**Re: FC-8614, Public Telephones at Hartsfield-Jackson Atlanta
International Airport**

Addendum No. 3

ADDENDUM NO. 3

EXHIBIT A.2: MAP OF PREMISES

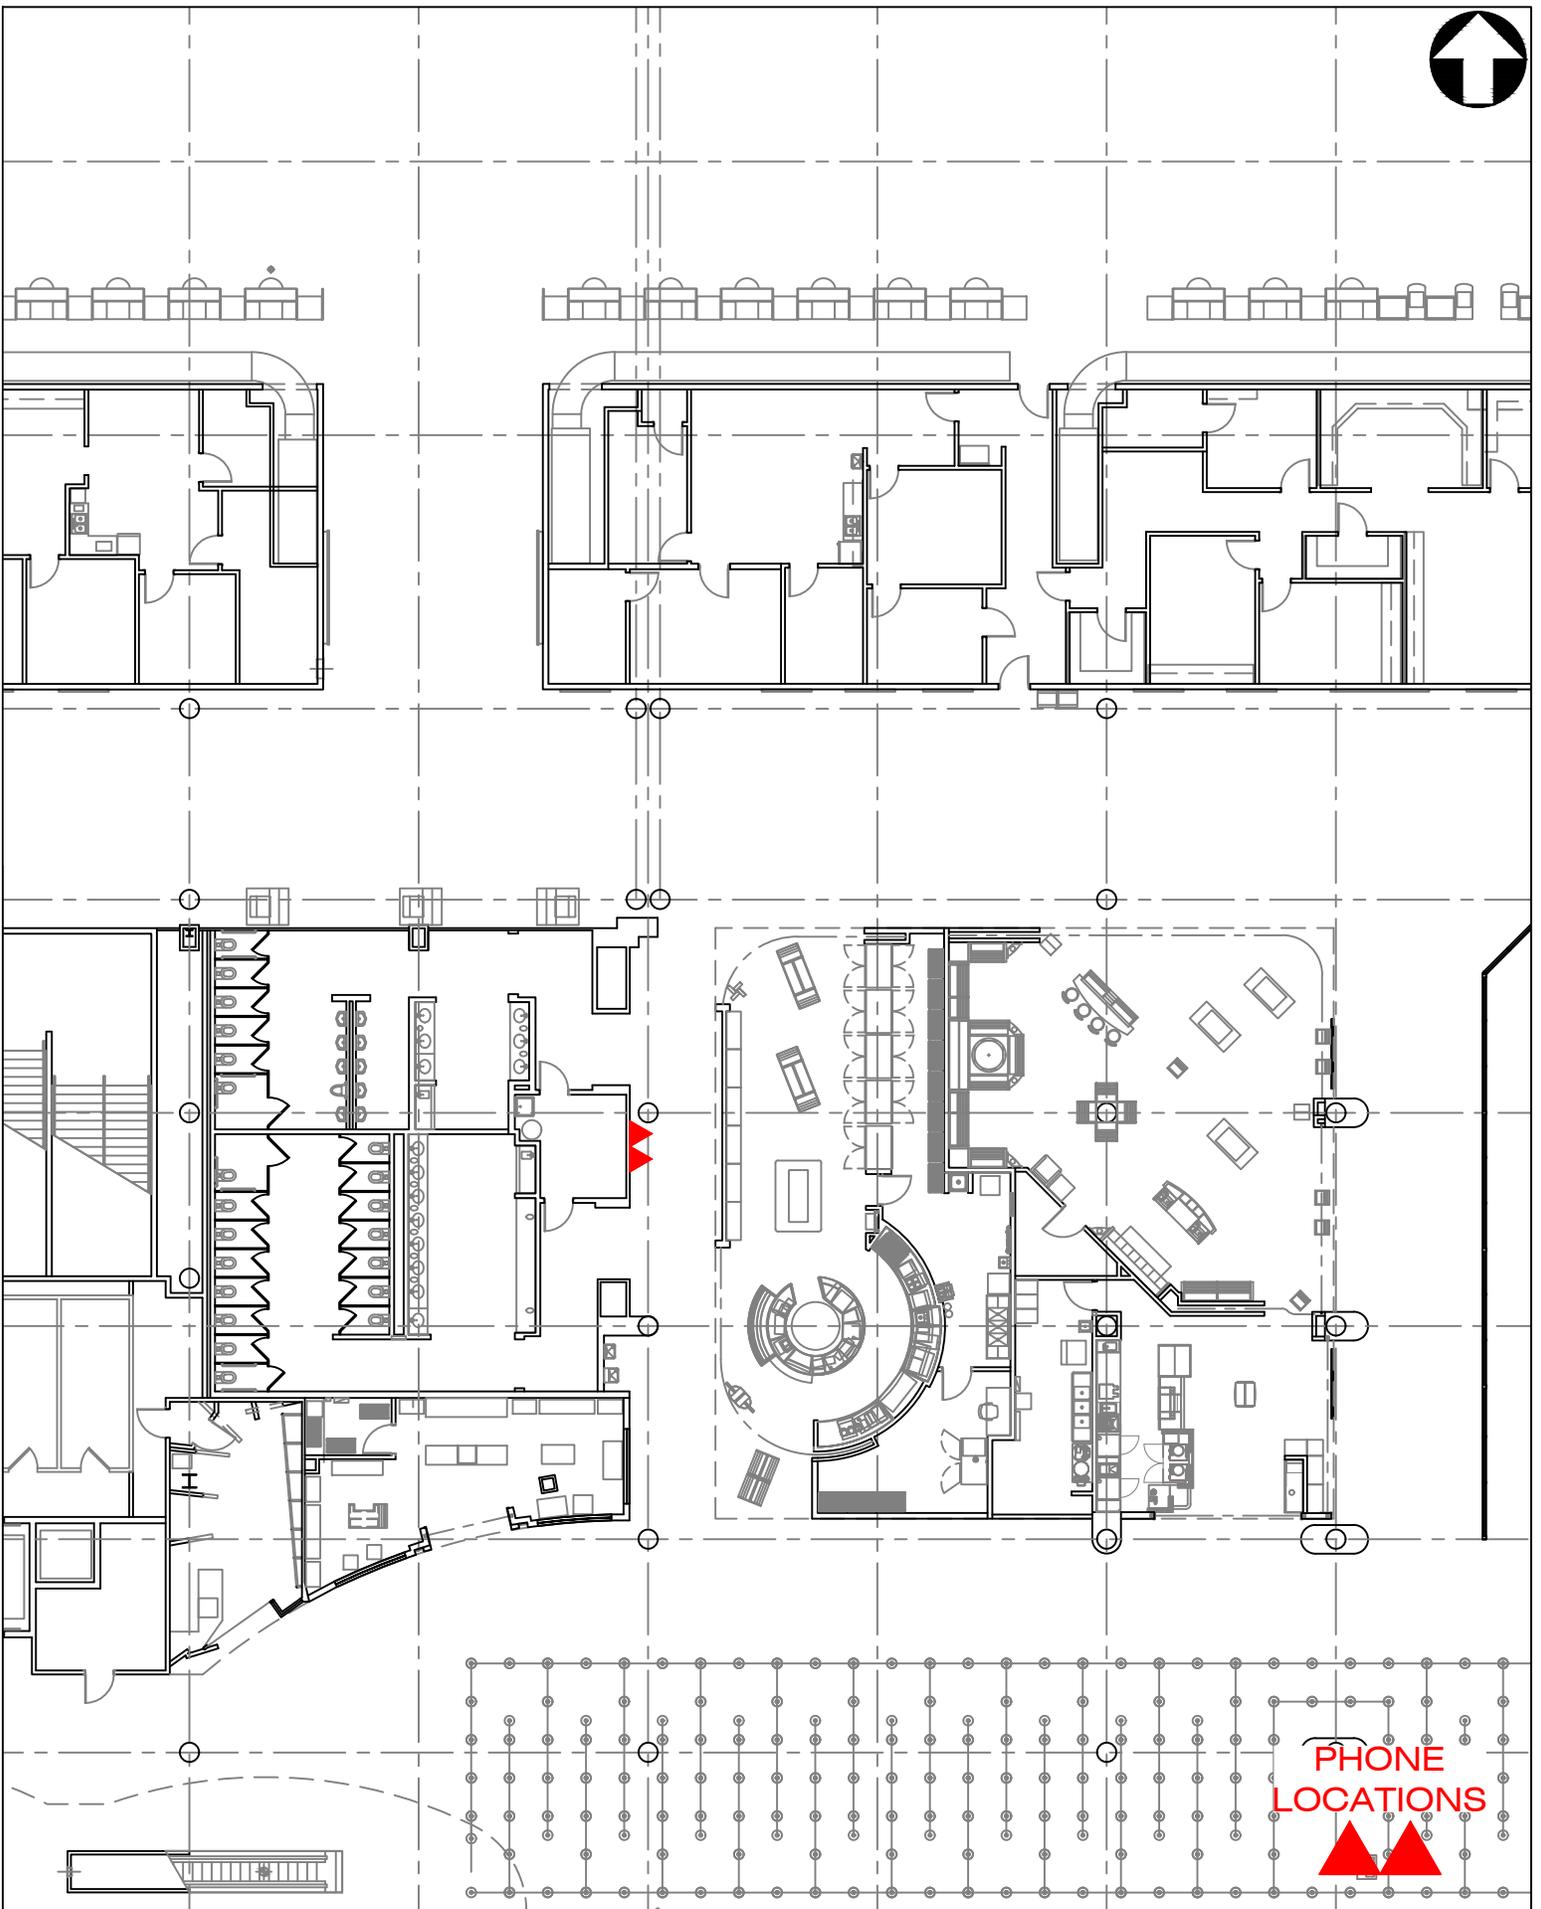
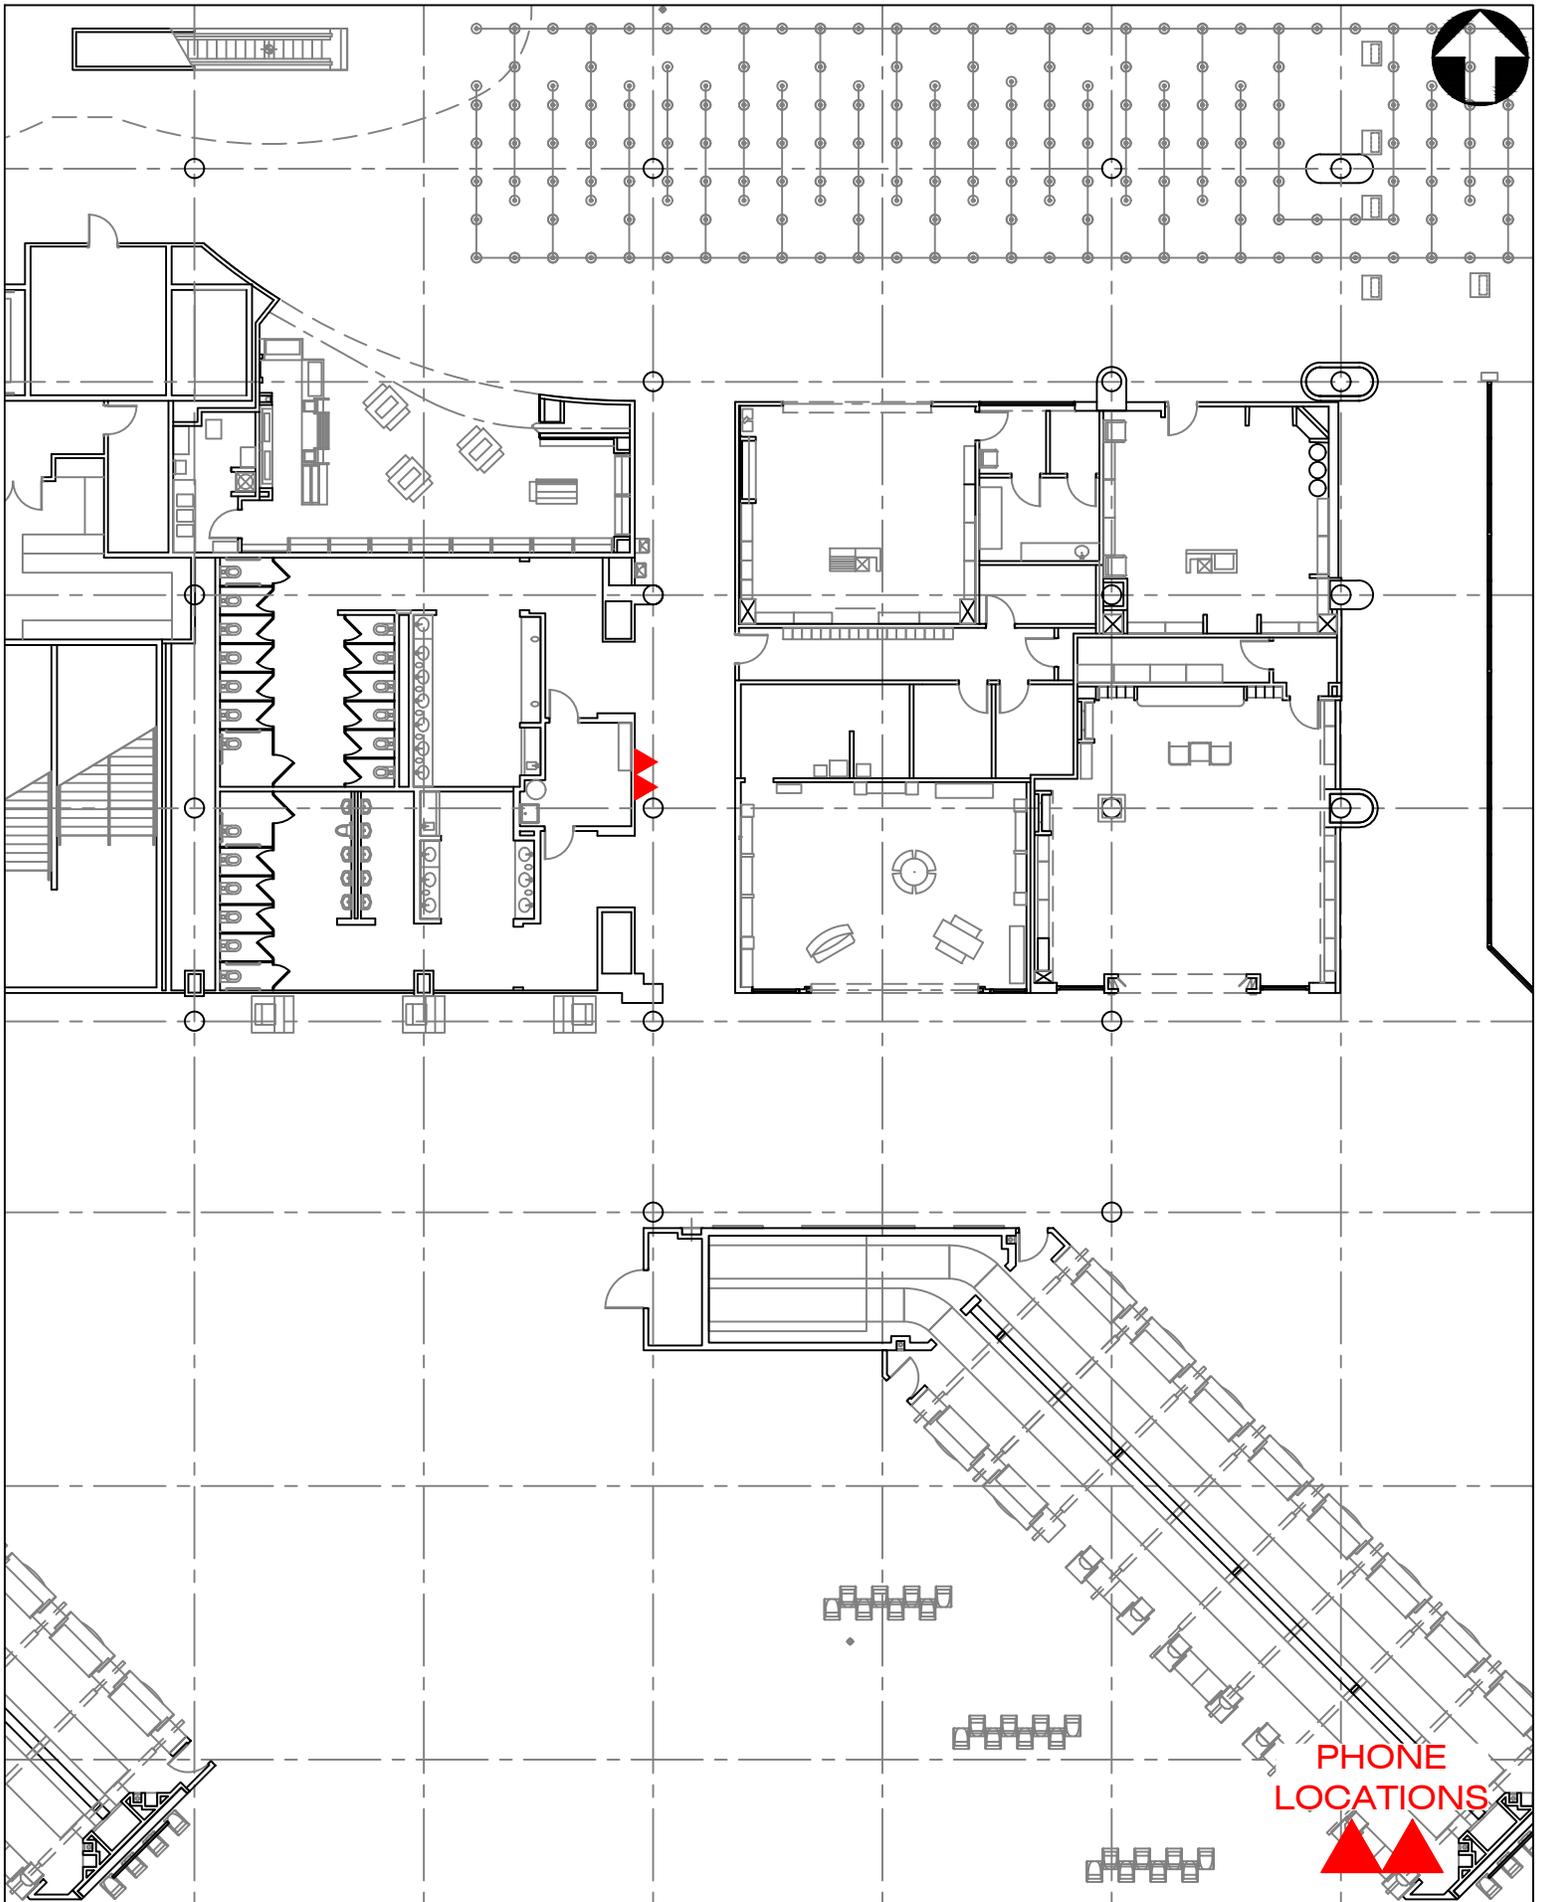
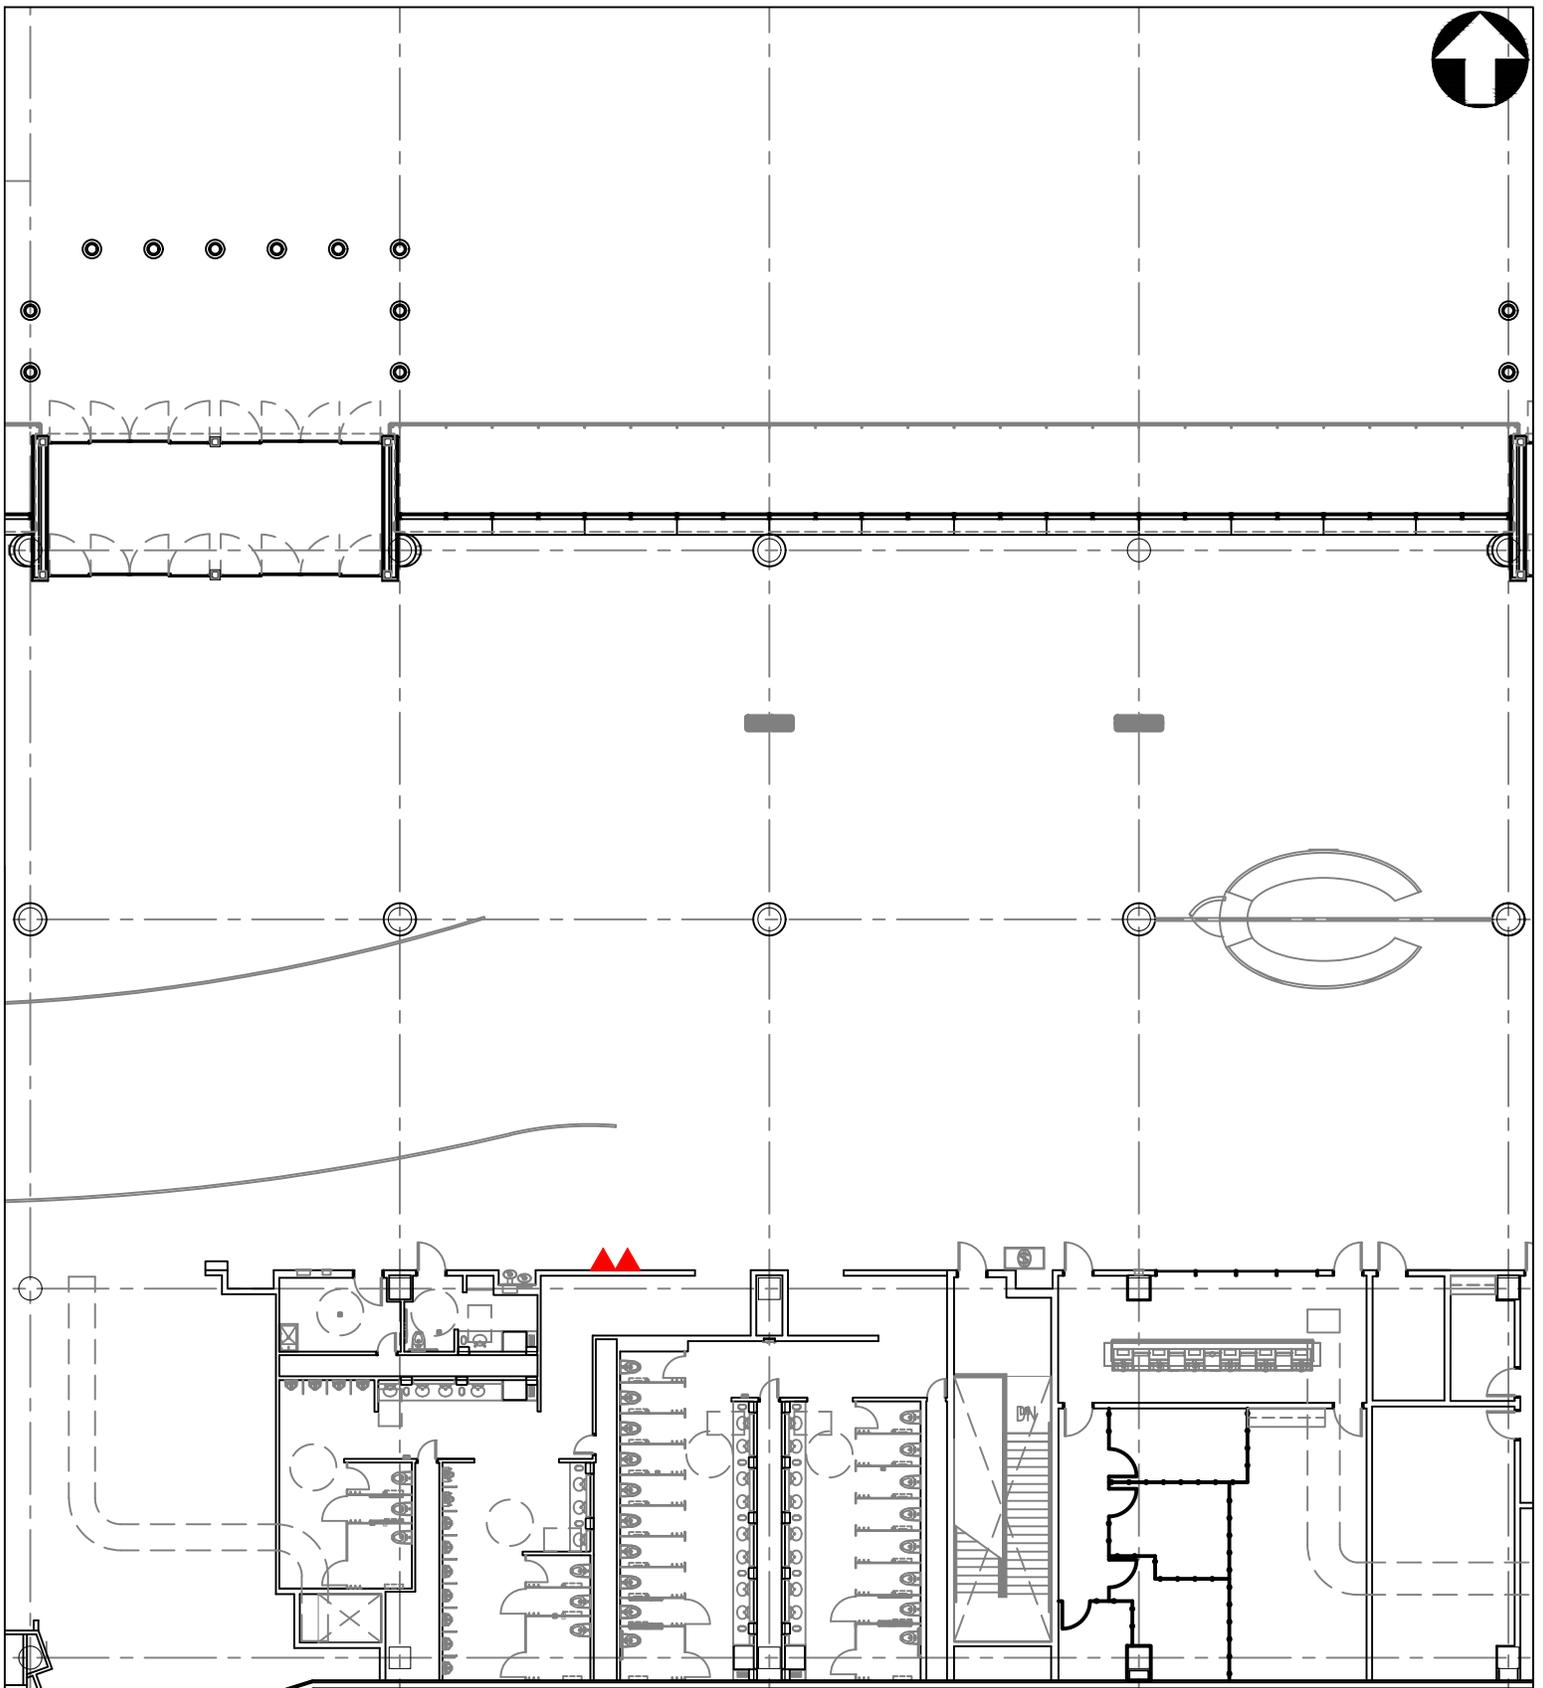
- **QUESTIONS AND RESPONSES: TOTAL OF FOURTEEN (14) QUESTIONS, ATTACHED HERETO AS ATTACHMENT NO. 1.**
- **REVISION TO TOTAL NUMBER OF LOCATIONS IN DOCUMENTS: LETTER FROM THE CHIEF PROCUREMENT OFFICER, MINIMUM QUALIFICATIONS, CONCESSIONS LEASE AGREEMENT, AND SCOPE OF SERVICES, ATTACHED HERETO AS ATTACHMENT NO. 2.**
- **REVISION TO EXHIBIT A.2: MAP OF PREMISES, ATTACHED HERETO AS ATTACHMENT NO. 3.**
- **PROPOSAL DUE DATE EXTENDED TO WEDNESDAY, JUNE 29, 2016**
